Town of Maynard

January 13, 2026 Planning Board Meeting

2. Public Hearing - 151 Main Street (Continued From December 9, 2025)

Peer Review Comment Form

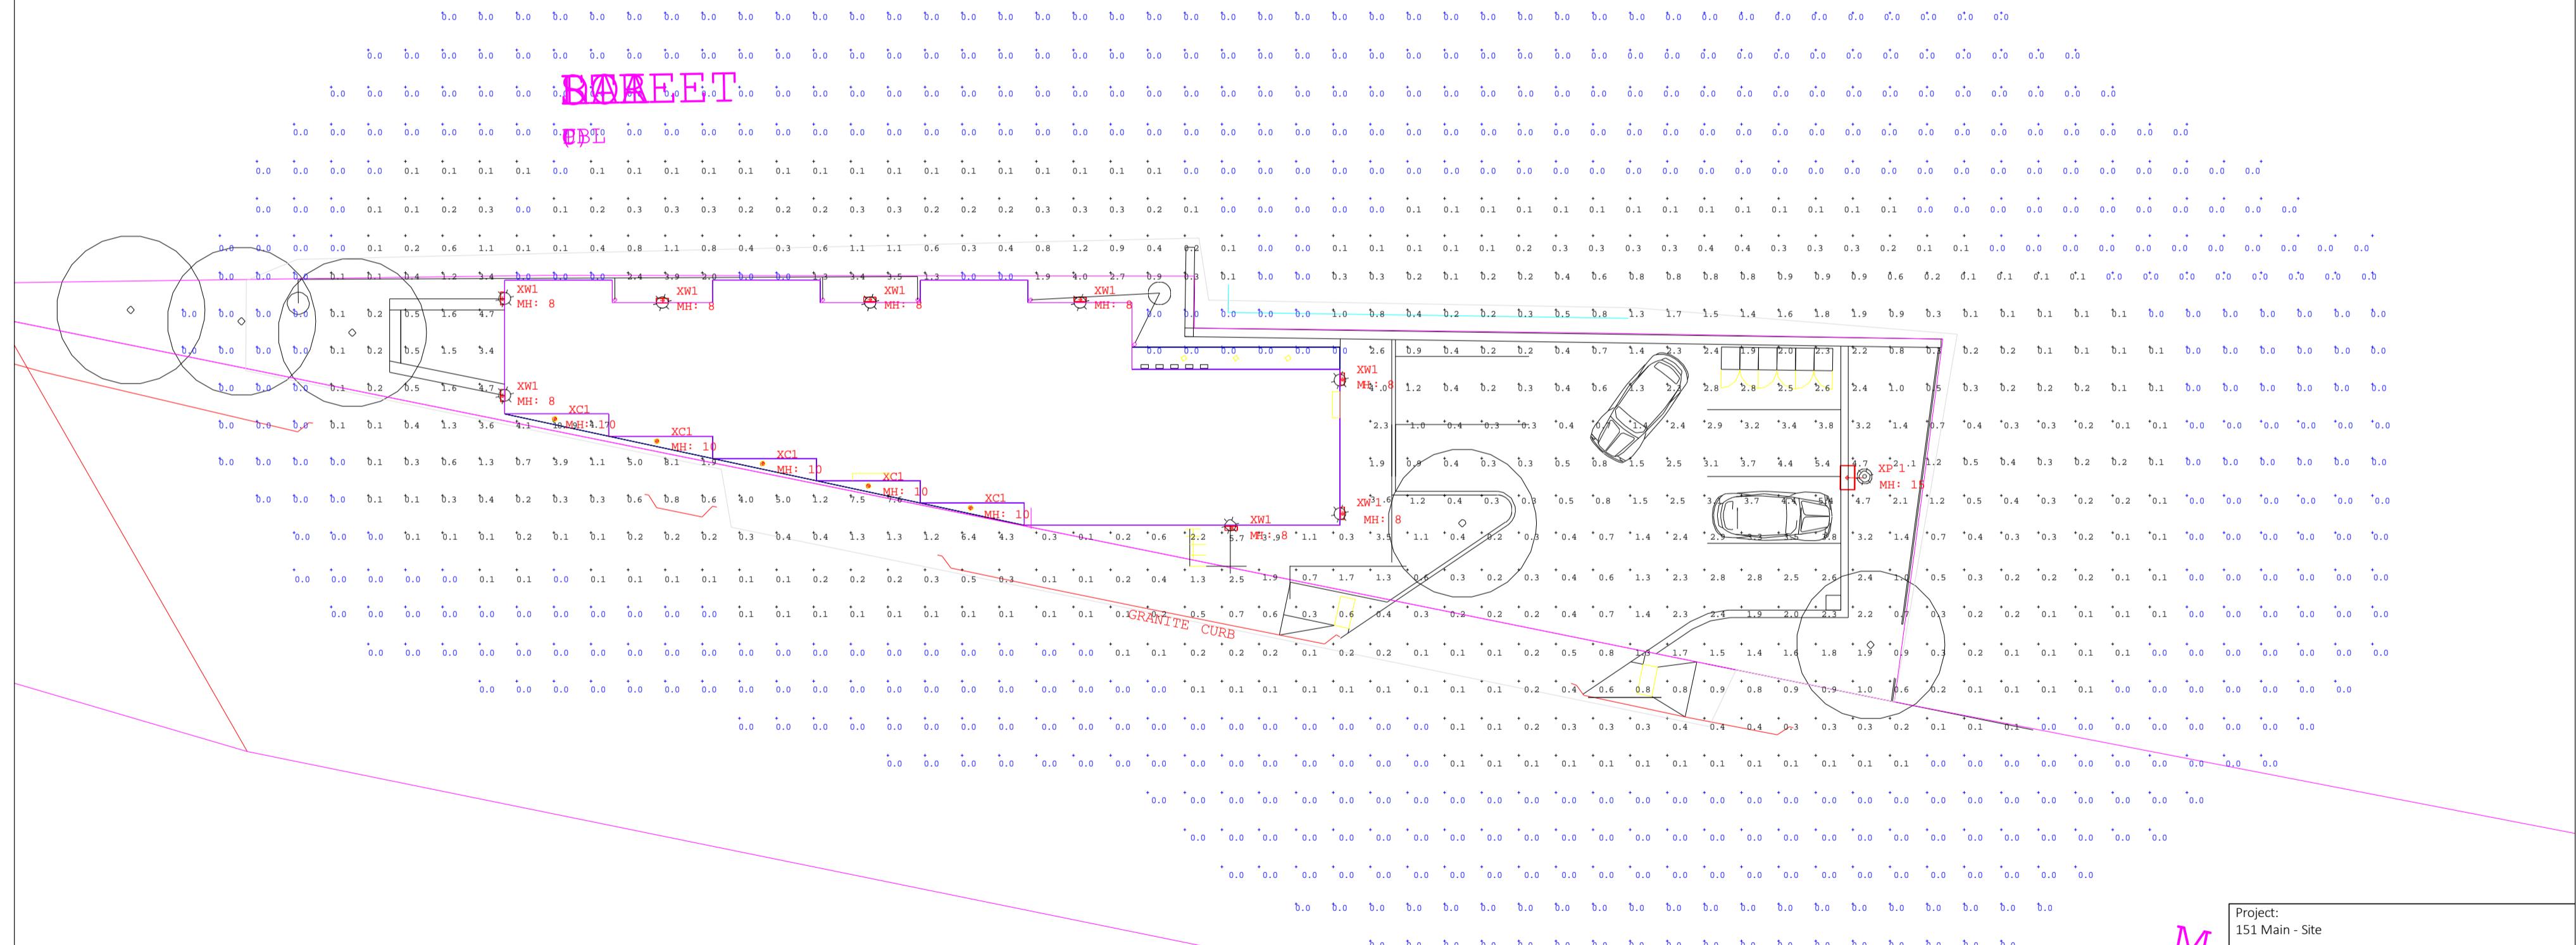
NO.	SHEET NO.	SECTION	GREEN'S COMMENT	Applicant's RESPONSE	CONFIRMED BY	DATE
30	Photometric Plan	PB Landscape Regs 5.9.2	Please confirm the shut off controls such as sensors, timers, and motion detectors to turn off lights when not needed.	Exterior lighting will be on timers located in mechanical area on the ground floor	JT	12/23/2025
31	Photometric Plan	PB Landscape Regs 5.9.2	Light spill across the property lines should not exceed 0.1 foot candles adjacent to business properties. The current light spill on the adjacent property to the east exceeds 0.1 foot candles. Please revise.	Please see PB comments regarding light levels at entries and north side.		
31A	Photometric Plan	PB Landscape Regs 5.9.2	We defer to the Board for approval.			
32	Photometric Plan	PB Landscape Regs 5.9.2	It is recommended that at building entrances and sidewalks foot candles do not exceed 5 fc. Please revise.	Please see PB comments regarding light levels at entries and north side.

32A	Photometric Plan	PB Landscape Regs 5.9.2	We defer to the Board for approval.			
33		Stormwater Management Regulations 7.A	The required stormwater treatment volume was not provided. Therefore, it is assumed that the project disturbs less than 10,000 sf. Please confirm the square feet of disturbed area is less than 10,000 sf or provide the required and provided stormwater treatment.	The project disturbs less than 10,000 square feet (the entire lot is only 7,521 square feet).	VR	12/10/2025

UTILITY PLAN
FOR: MATTHEW HALL
SCALE: 1"=20'
OCTOBER 9, 2025
REVISED: DEC 4, 2025

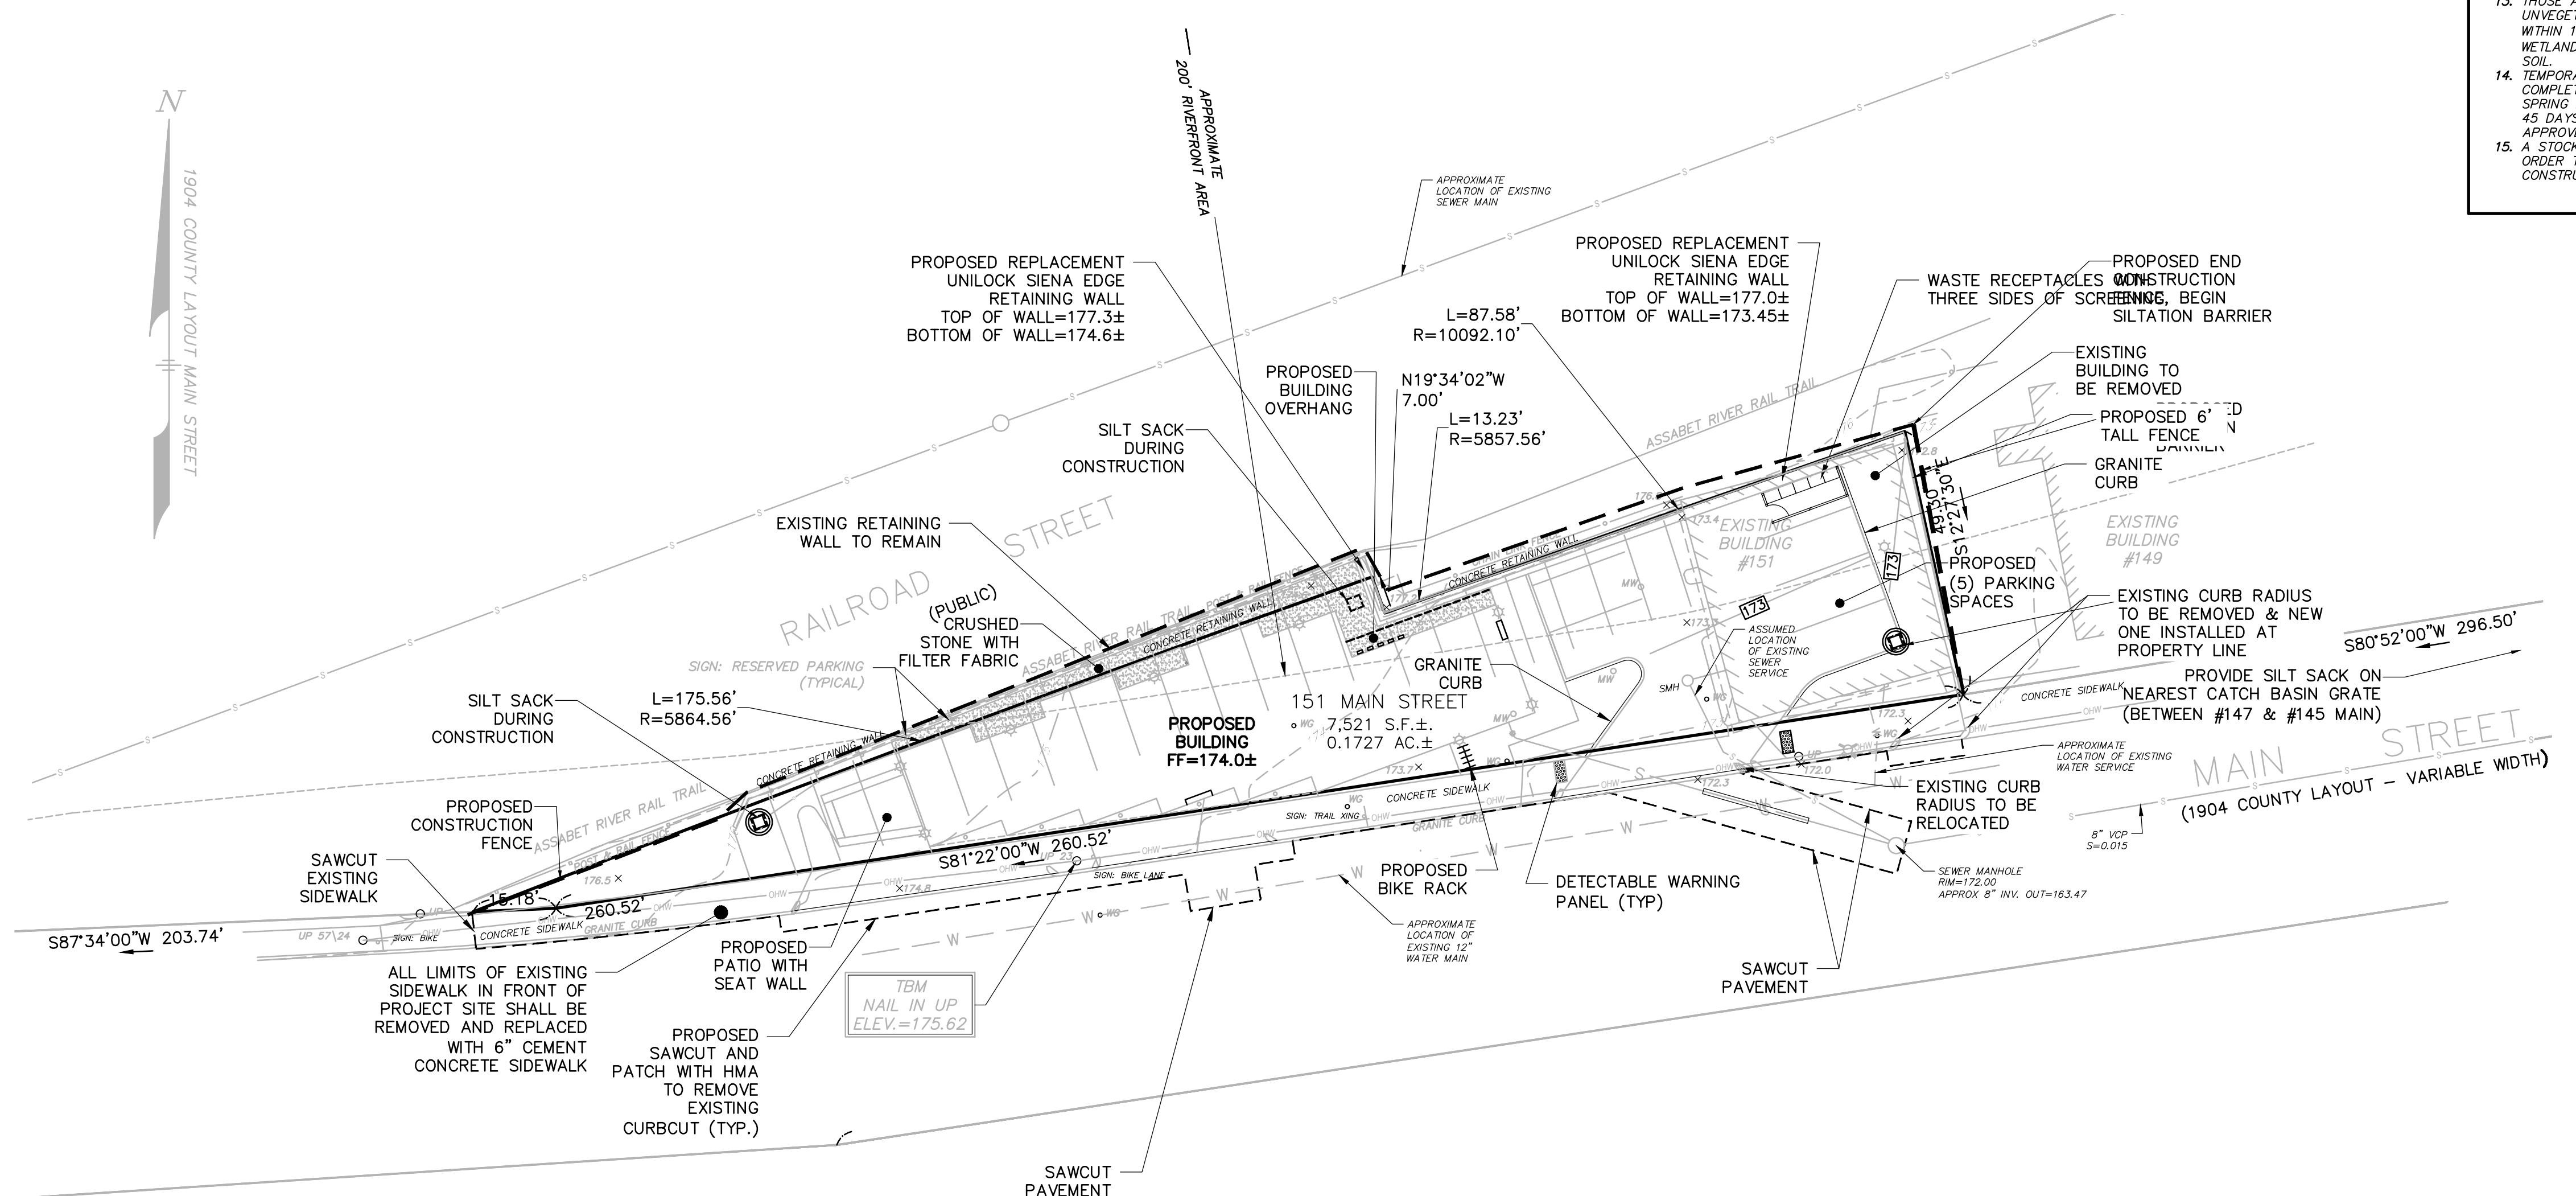
14	Utility Plan	PB Rules & Regs C.9	Has a system capacity analysis been performed and submitted to the DPW?	The DPW has confirmed adequate capacity for this project in terms of water demand.		
14A	Utility Plan	PB Rules & Regs C.9	We defer to the DPW for approval.			
15	Utility Plan	PB Rules & Regs H.3	Has the project been reviewed by the Fire Department to confirm how fire alarm and terminal boxes shall be installed and for fire access to the site?	The fire alarm and terminal box layout has not yet been finalized but will be coordinated with the Maynard Fire Department.

NO.	SHEET NO.	SECTION	GREEN'S COMMENT	Applicant's RESPONSE	CONFIRMED BY	DATE
15A	Utility Plan	PB Rules & Regs H.3	We recommend this be made a condition of approval.			
16	Utility Plan		The WATER MAIN CONNECTION DETAIL shows both an 8" and a 12" existing water main, please clarify. This also only seems to be a detail for the fire protection line, please revise or provide additional detail to also show the 2" domestic service. Also, the plan indicates a cut in tee but the detail indicates a tapping sleeve and valve. Please confirm with the DPW on the preferred connection.	The detail has been corrected to note the water main as 12". The detail has also been added to say "or 2" domestic".		
16A	Utility Plan		We defer to the DPW for approval.			
17	Utility Plan		Have test pits been performed to confirm soils are suitable for infiltration and the seasonal high groundwater is at least 2' below the bottom of the leaching basin? The soil onsite is potentially contaminated. Have soil sampling been performed to confirm the contamination of the soil is ok for infiltration BMPs? This should be sampled and confirmed by an Licensed Site Professional (LSP).	No, site is covered by Building and paving. Construction of the rail trail at the west corner did not encounter contaminants.	JT	12/23/2025

17A	Utility Plan		Based on the Planning Board Hearing, the Engineer is responsible for confirming the leaching basin has adequate separation to groundwater so, the BMP will function properly.		JT	12/23/2025
18	Utility Plan		WATER & SEWER CROSSING DETAIL the detail does not match what is shown in the plan. In the detail, the water main has the sleeve, but in the plans the sewer has a sleeve. Typically the sewer is encased at the crossings. Please clarify.	The detail has been corrected with the water and sewer pipe labels swapped to accurately reflect how the sewer line is proposed to be encased at the water crossing.	VR	12/9/2025
19	Utility Plan		How will the sewer manhole and pipe be abandoned? Will it filled and plugged at the active manhole?	The DPW has requested that the sewer manhole be removed. The pipe can be abandoned in place or removed from site if encountered during construction.	JT	12/23/2025

20	Utility Plan		It is not recommended to have an infiltration BMP such as the leaching basin within 10 feet of a building even if it is on a slab foundation. Please consider revising.	The leaching catch basin behind the proposed building has been removed.	VR	12/9/2025
21	Utility Plan		A detail for the crushed stone in the rear of the building should be provided. It is unclear from the grading, is this area able to drain out to the east behind the building?	Added a dispersion trench detail for the rear of building, surface flow graded to drain out	VR	12/10/2025
22	Stormwater Pollution Prevention Plan		Please indicate on the plans where each erosion control measure is being proposed.	Sheet 6 of the plan set shows a construction fence around the whole area of work, except for where a siltation barrier is proposed along the eastern edge of the project. Most of the site is downgradient of the neighboring areas except for this eastern portion. Additionally, silt sacks are proposed within the on-site proposed catch basins as well as in the existing catch basin between #145 and #147 Main Street (label with arrow on plan).	JT	12/23/2025

1 PLANTING PLAN

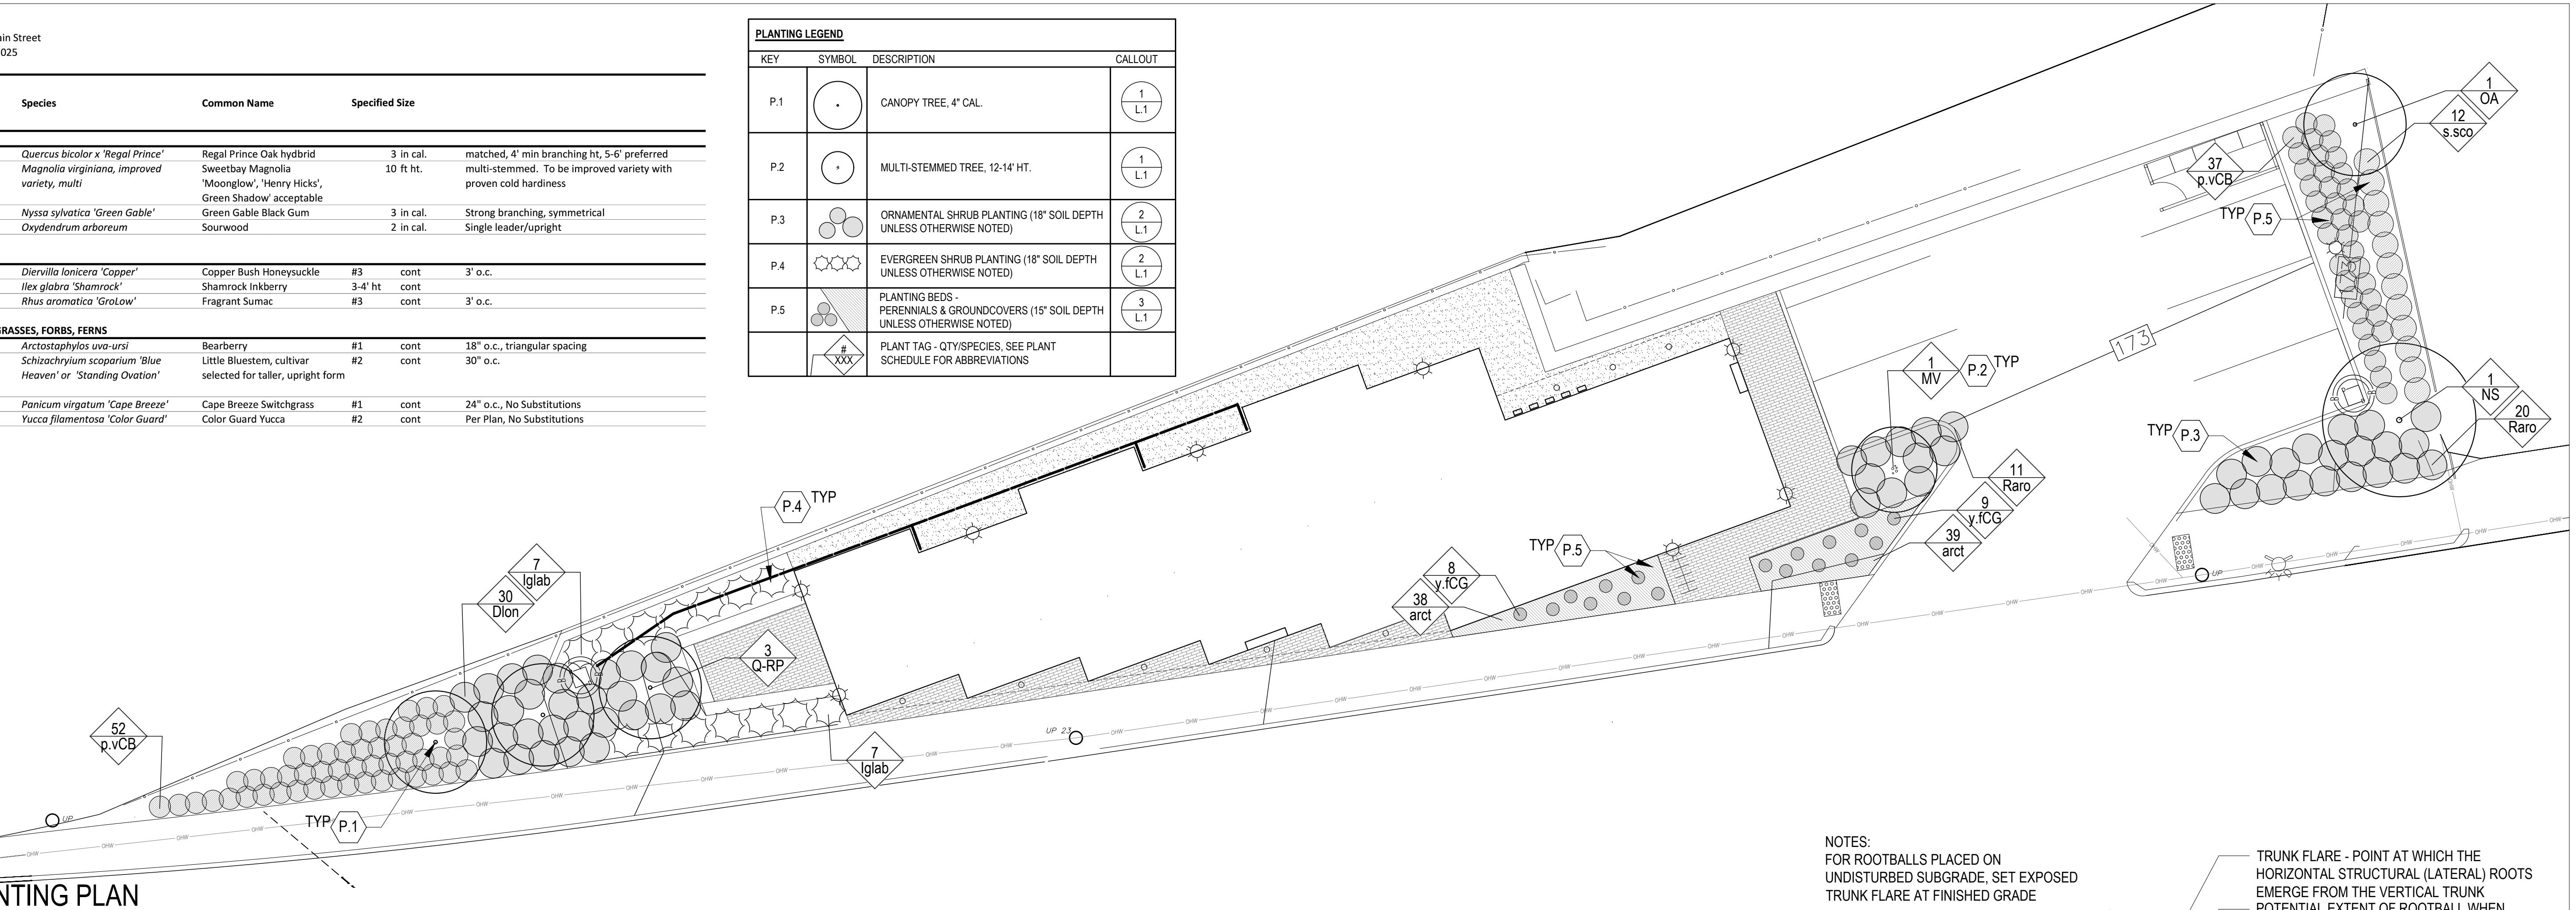
27	Landscape Plan	PB Landscape Regs 5.6.3	A fence is required in locations where a vegetative buffer is not practical. Please revise.	See revised plans	JT	12/23/2025
28	Landscape Plan	PB Landscape Regs 5.6.4	Trash receptacles are shown. There is a requirement for screening. Please provide details of trash enclosures or whatever screening is possible.	We have changed from trash lockers to conventional totes with screening.		
28A	Landscape Plan	PB Landscape Regs 5.6.4	We defer to the Board for approval.			
29	Photometric Plan	PB Landscape Regs 5.9.2	Details for the lighting proposed was not provided. Please confirm the fixtures are dark sky compliant and the heights meet the Maynard PB Landscape Regs. Please confirm the light fixtures have zero uplight or are fully shielded.	Lighting cuts for fixtures used in photometric plan have been provided, see PB comments regarding light levels at entries.	JT	12/23/2025
